AMENDMENT TO
PUBLIC AGENCY PERMIT

13715 STREET
SACRAMENTO, CALIFORNIA 95814 DraftNEGATIVE DECLARATION

Project Title: Chevron El Segundo Groin and County Outfall Extension

MITIGATION *

FIGURE 9

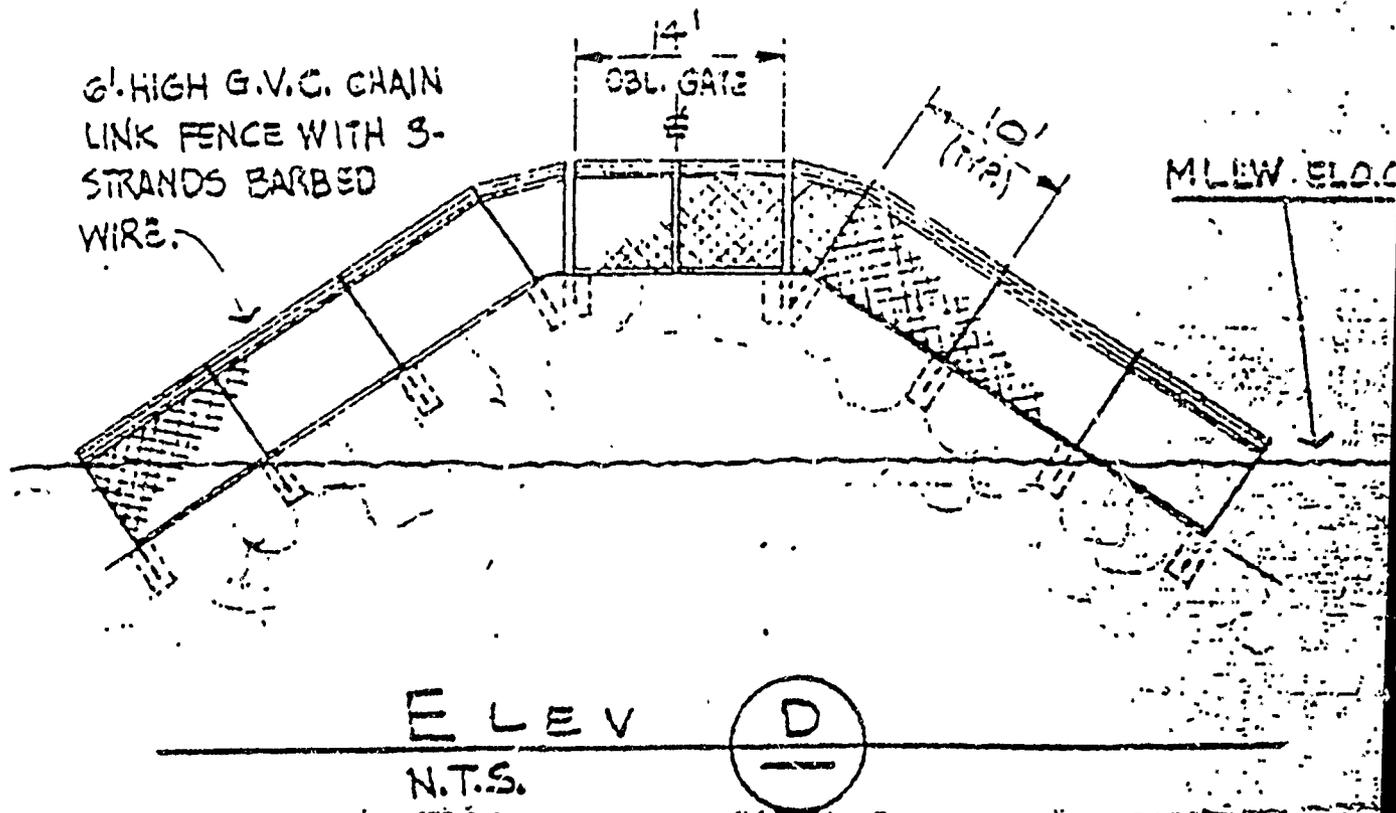
It was pointed out that the groin will constitute an "attractive hazard" if there is access to the structure by the public, and that maintenance and liability responsibilities should be clearly specified. Chevron is constructing a privately-owned structure specifically to protect their own private property being threatened by ocean erosion. As such, it is in Chevron's interest and is their intent to maintain the groin so that it continues to perform its intended function. To minimize the "attractive hazard" aspects of the structure, a 6-foot high chain link fence will be constructed approximately mid-way in the length of the groin to minimize the possibility of access to parts of the groin adjacent to and in contact with the sea. In addition, a guard rail and chain will be located at the shoreward end of the groin to prevent bicyclists from gaining easy access to the top of the groin. These two security structures are shown in attached Figures 9 and 10. Chevron will assume liability for construction and maintenance of the groin, and will provide the County and/or State with documentation relieving them from any such liability.
